# Technical Bulletin

Bulletin No.: PRO-01-38

## Subject: Tu-Flo 501 Three Ring Piston and Pin Kit Obsolescence

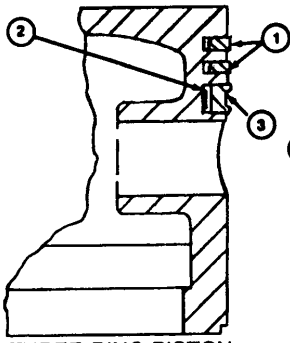
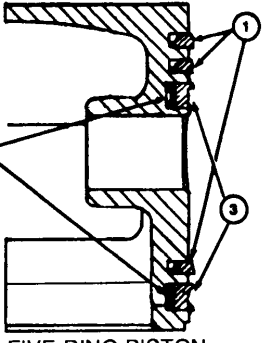
Effective immediately the Tu-Flo 501 three ring piston and pin kit is being obsoleted and superseded by a five ring configuration for all service new and remanufactured compressors. Provided the additional rings are installed, the five ring piston is directly interchangeable with the three ring piston.

Below is a listing of the three ring piston and pin kits and ring sets and their appropriate five ring replacement. The new ring set is designed to service the new five ring pistons as well as the obsolete three ring pistons. When servicing the three ring piston refer to the instruction sheet provided in the kit to ensure the appropriate rings are discarded.
